Well Name	Well Number	US Well Number	Lease Number	Case Number	Operator
GATO GRANDE 9-	601H	3002551815	NMNM98192	NMNM98192	DEVON
GATO GRANDE 9-	701H	3002551325	NMNM98192	NMNM98192	DEVON
GATO GRANDE 9-	801H	3002551327	NMNM98192	NMNM98192	DEVON

Notice of Intent

Procedure Description: Devon Energy Production Co., L.P. (Devon) respectfully requests a variance to break test. Please see attachment.

## PECOS DISTRICT DRILLING CONDITIONS OF APPROVAL

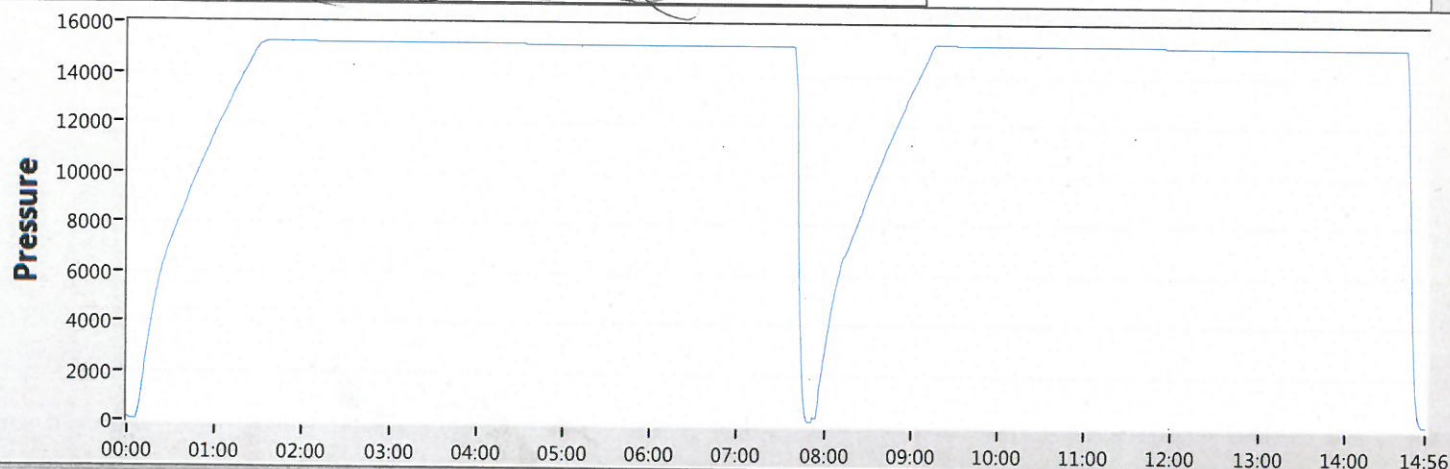
Devon Energy requests to only test BOP connection breaks after drilling out of surface casing and while skidding between wells which conforms to API Standard 53 and industry standards. This test will include the Top Pipe Rams, HCR, Kill Line Check Valve, QDC (quick disconnect to wellhead) and Shell of the 10M BOPE to 5M for 10 minutes. If a break to the flex hose that runs to the choke manifold is required due to repositioning from a skid, the HCR will remain open during the shell test to include that additional break. The variance only pertains to intermediate hole-sections and no deeper than the Bone Springs Formation where 5M BOP tests are required. The initial BOP test will follow OOGO2.III.A.2.i, and subsequent tests following a skid will only test connections that are broken. The annular preventer will be tested to 100% working pressure. This variance will meet or exceed OOGO2.III.A.2.i per the following: Devon Energy will perform a full BOP test per OOGO2.III.A.2.i before drilling out of the intermediate casing string(s) and starting the production hole, before starting any hole section that requires a 10M test, before the expiration of the allotted 14-days for 5M intermediate batch drilling or when the drilling rig is fully mobilized to a new well pad, whichever is sooner. We will utilize a 200' TVD tolerance between intermediate shoes as the cutoff for a full BOP test. The BLM will be contacted 4hrs prior to a BOPE test. The BLM will be notified if and when a well control event is encountered. Break test will be a 14 day interval and not a 30 day full BOPE test interval. If in the event break testing is not utilized, then a full BOPE test would be conducted.

1. Well Control Response:
  1. Primary barrier remains fluid
  2. In the event of an influx due to being underbalanced and after a realized gain or flow, the order of closing BOPE is as follows:
    - a) Annular first
    - b) If annular were to not hold, Upper pipe rams second (which were tested on the skid BOP test)
    - c) If the Upper Pipe Rams were to not hold, Lower Pipe Rams would be third

**All Previous COAs Still Apply. Variance request procedure is approved as written, please see below general conditions for variance.**

- **BOPE Break Testing is ONLY permitted for 5M BOPE or less. (Annular preventer must be tested to a minimum of 70% of BOPE working pressure and shall be higher than the MASP)**

- **BOPE Break Testing is NOT permitted to drilling the production hole section.**
- **Variance only pertains to the intermediate hole-sections and no deeper than the Bone Springs formation.**

- **A full BOPE test is required prior to drilling the first deep intermediate hole section. If any subsequent hole interval is deeper than the first, a full BOPE test will be required. (200' TVD tolerance between intermediate shoes is allowable).**
